THIS IS FOR THE PURPOSE OF SECTION 4.55 APPLICATION TO COUNCIL ONLY

SECTION 4.55 ISSUE: FF'S FACADE MATERIAL UPDATED. LOWER SECTION OF KITCHEN'S SOUTHERN FACADE UPDATED.

41 & 43 BEACH ROAD COLLAROY
LO1 1 DP300846 AND LOT 2 SEC 7 DP7391

DRAWING TITLE
SOUTH & WEST ELEVATIONS
PROPOSED

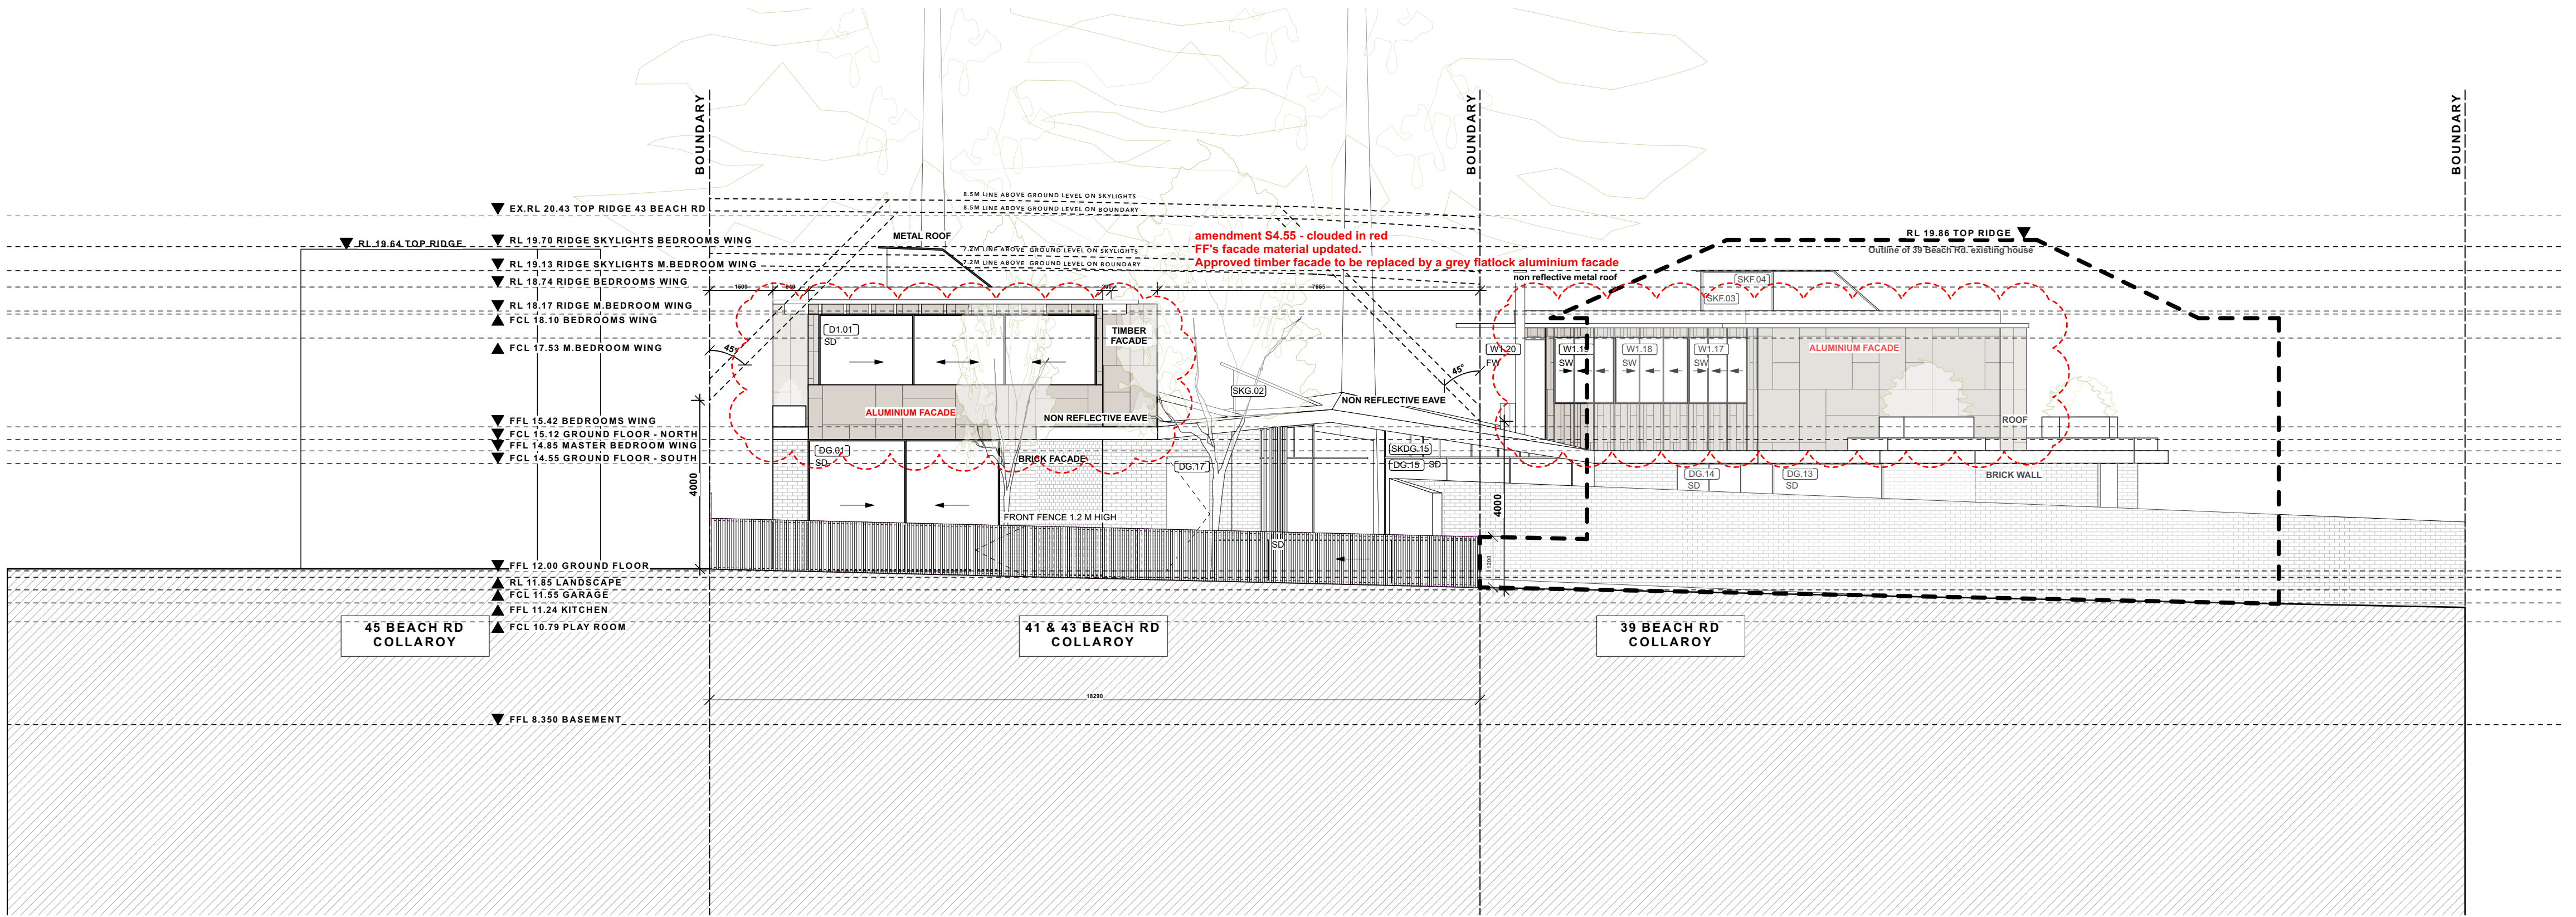
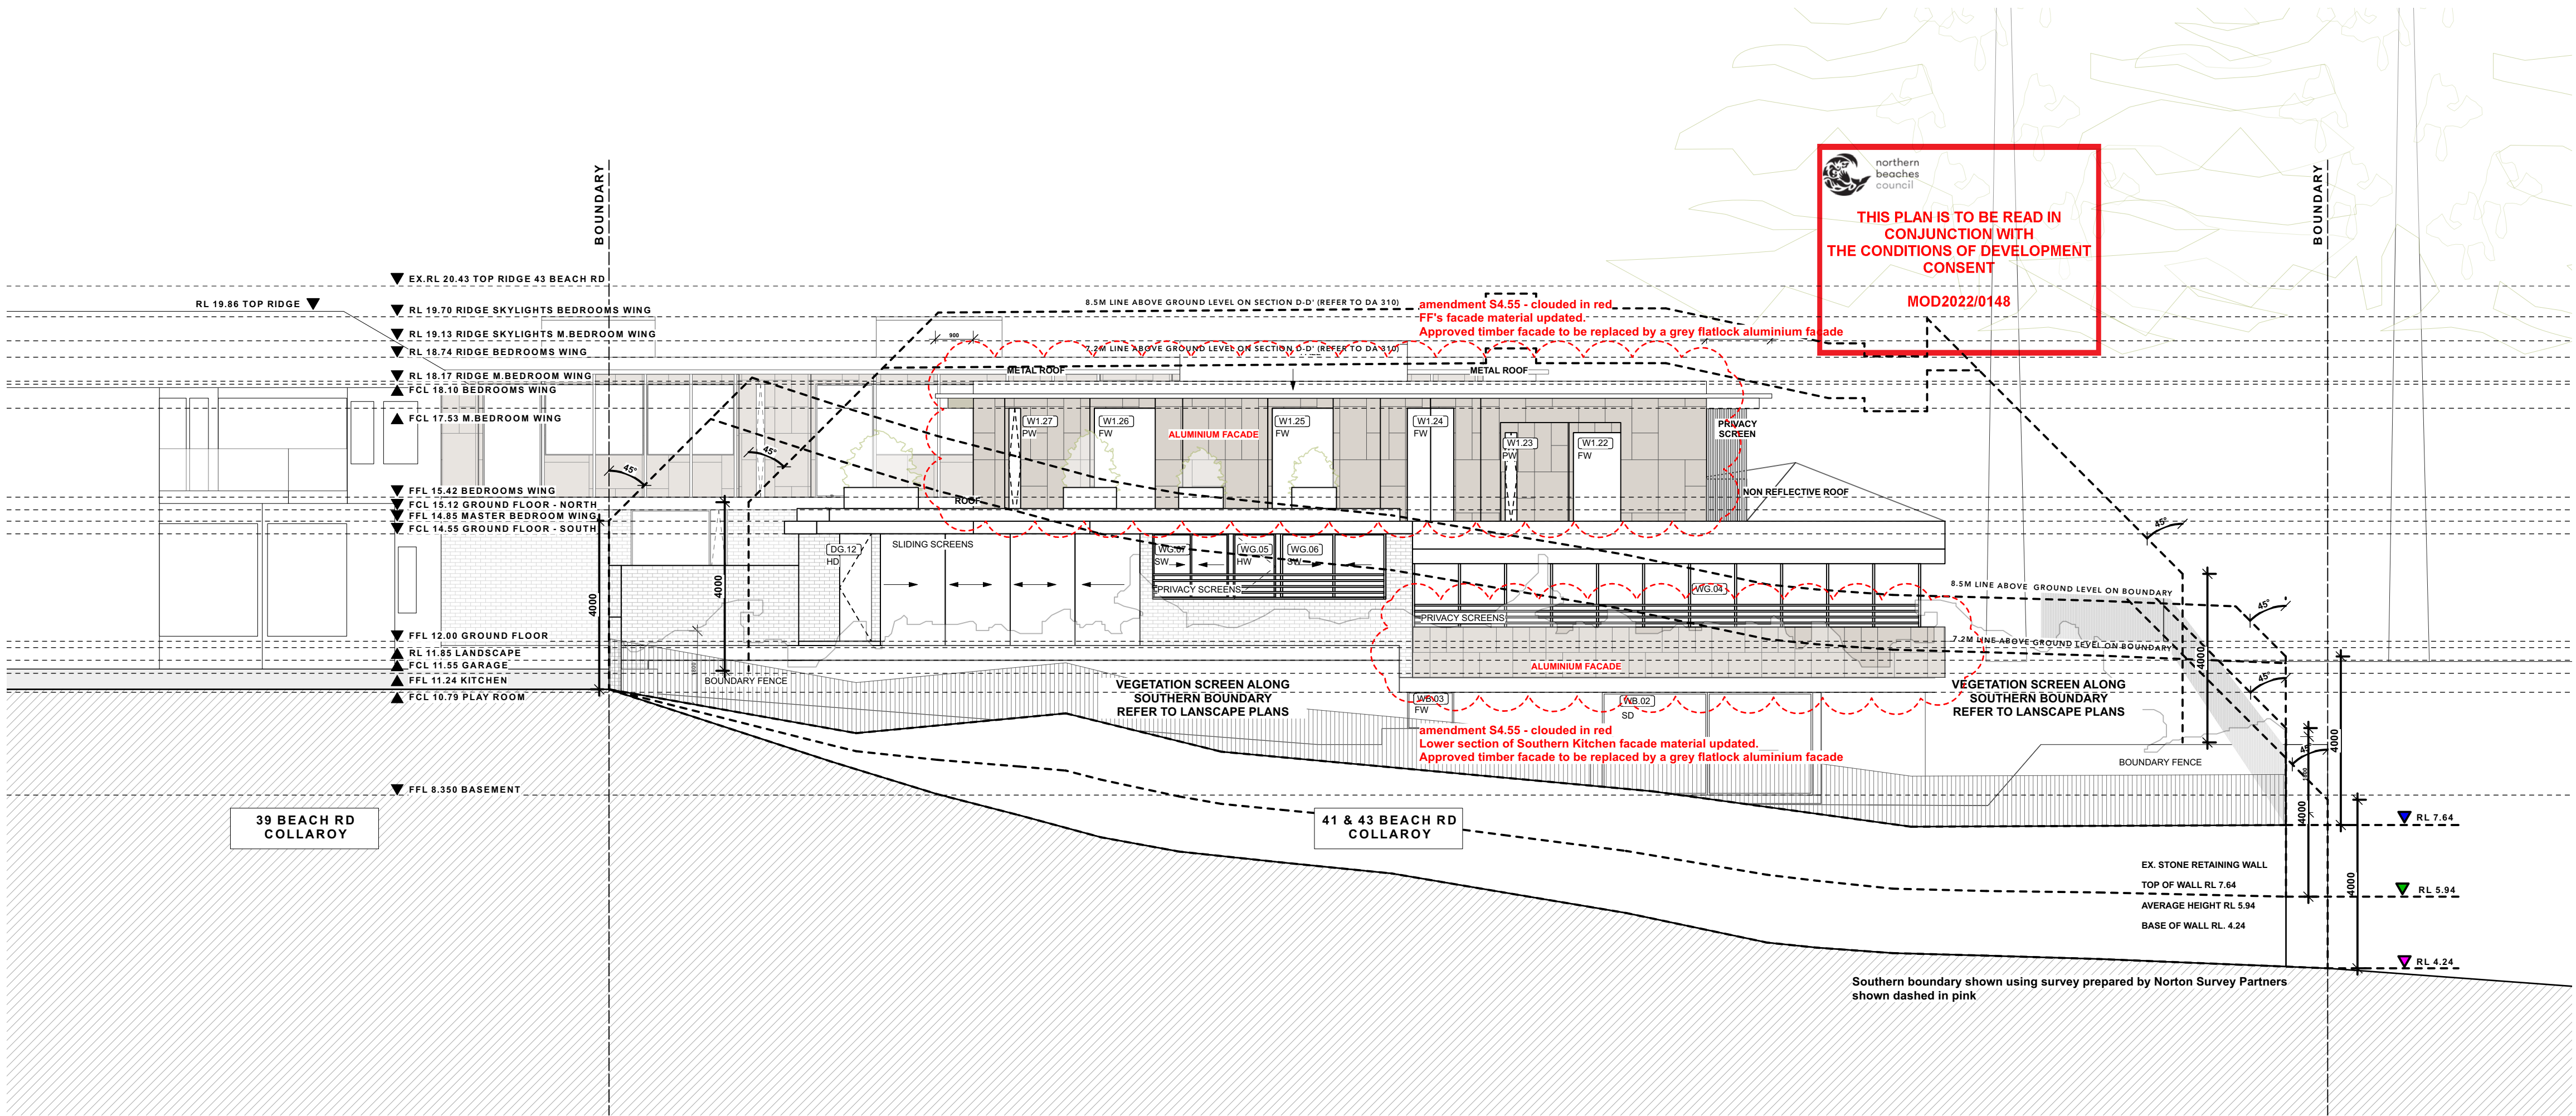
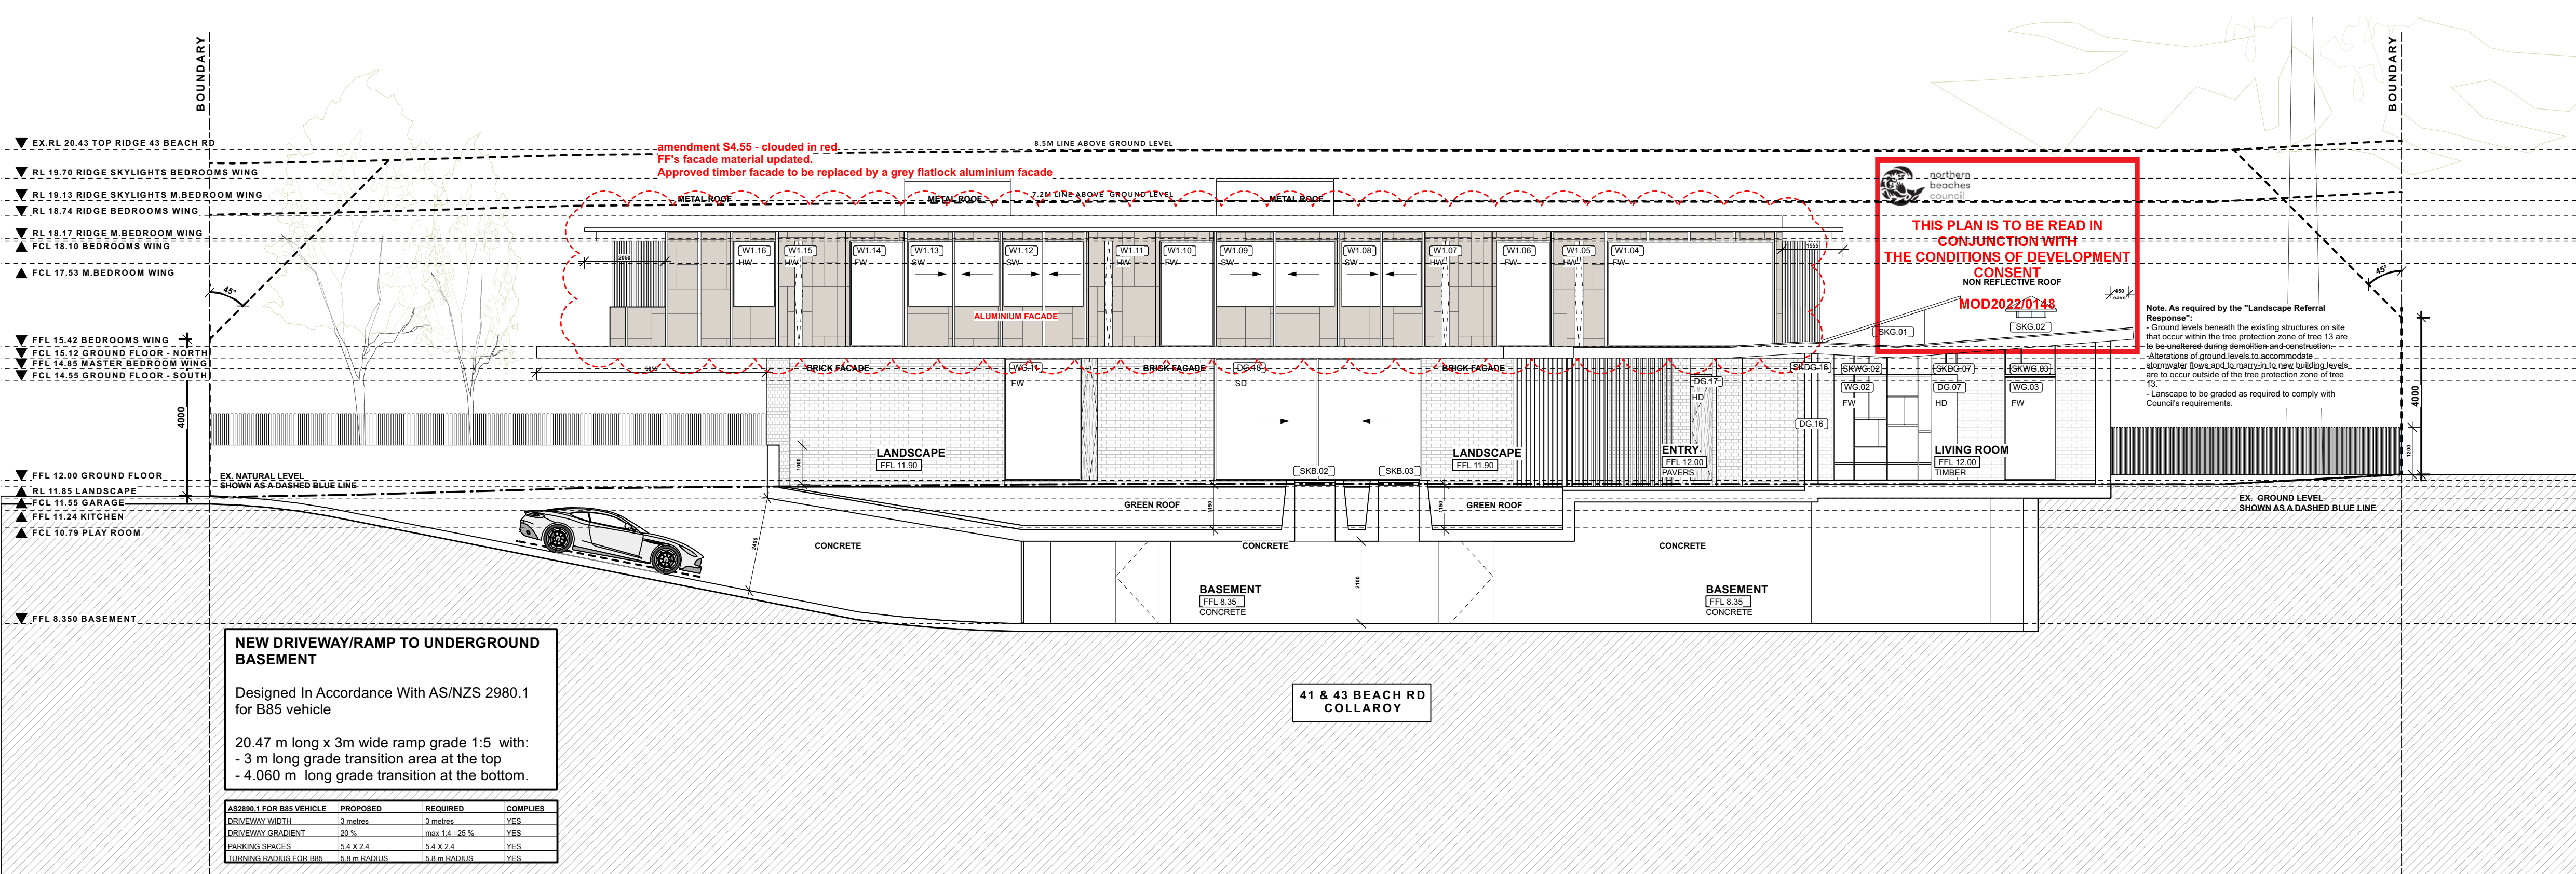
DESCRIPTION
SECTION 4.55 ISSUE: FF'S FACADE MATERIAL UPDATED. LOWER SECTION OF KITCHEN'S SOUTHERN FACADE UPDATED.

DRAWING TITLE		SCALE:	DRAWING NO.	
			PROPOSED SECTIONS C-C' & E-E'		1:100 at A1 & 1:200 at A3	S4.55 310

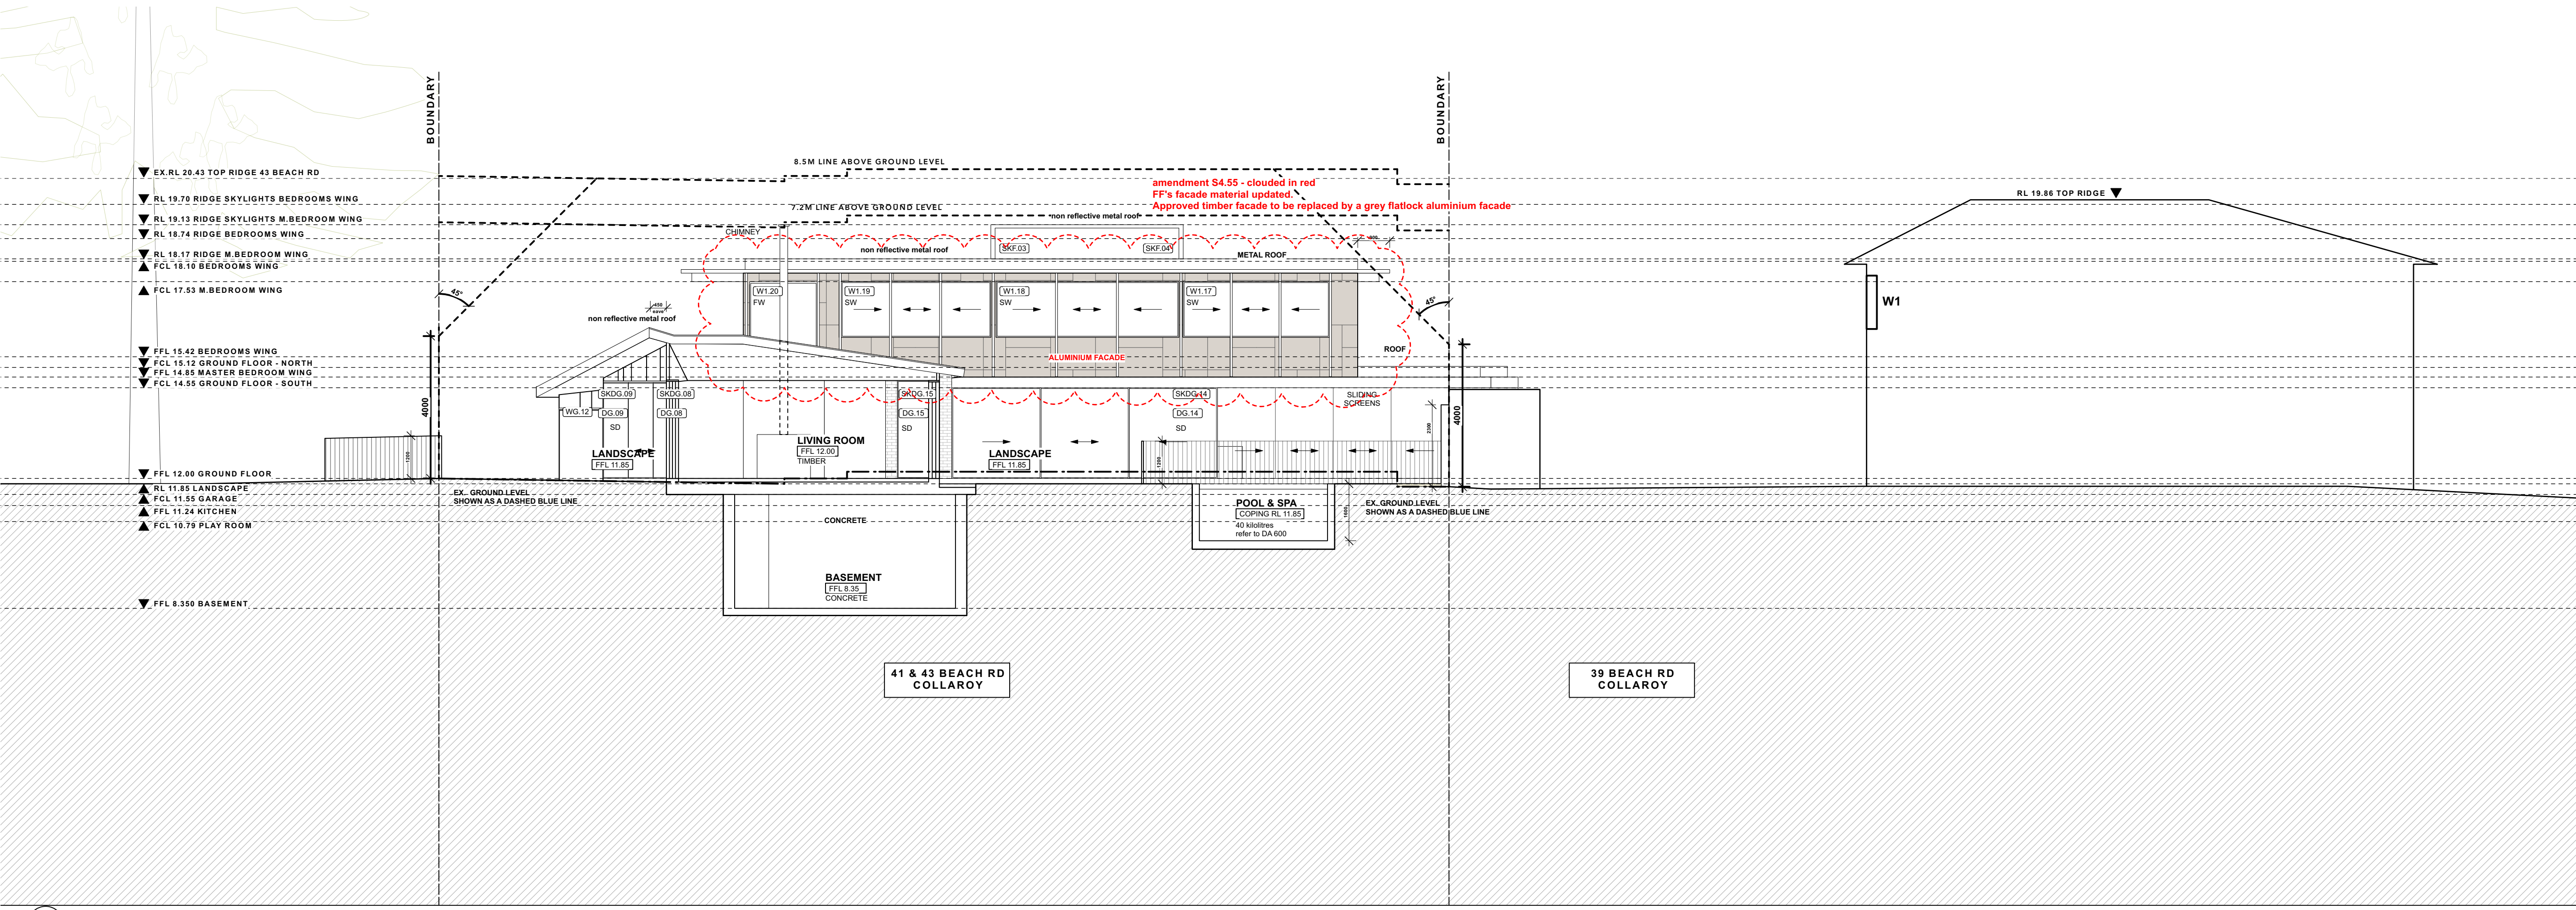
VIRGINIA KERRIDGE ARCHITECT g 03 / 59 great buckingham street redfern nsw 2016 ph 02 9699 3487 ph 02 9699 8527 fax 02 9699 4626 info@vk.com.au www.vk.com.au abn 12 083 17 159	NOTES: THIS IS FOR THE PURPOSE OF SECTION 4.55 APPLICATION TO COUNCIL ONLY REFER TO WRITTEN DIMENSIONS ONLY, DO NOT SCALE FROM DRAWINGS. REFER TO ARCHITECTS SPECIFICATION AND SCHEDULES IN RELATION TO THESE DRAWINGS. REFER ALL DISCREPANCIES TO THE ARCHITECT IMMEDIATELY BEFORE PROCEEDING. REFER TO ALL CONSULTANTS DRAWINGS AND SPECIFICATIONS FOR ALL SPECIALIST INFORMATION AND DETAILS. REFER TO SURVEY DRAWING FOR ALL EXISTING GROUND LEVELS.	amendments:			PROJECT	DATE	REVISION NUMBER
		DATE	REV	DESCRIPTION	41 & 43 BEACH ROAD COLLAROY LO1 1 DP300846 AND LOT 2 SEC 7 DP7391	16/03/2022	A
		16/03/2022	A	SECTION 4.55 ISSUE: FF'S FACADE MATERIAL UPDATED. LOWER SECTION OF KITCHEN'S SOUTHERN FACADE UPDATED.
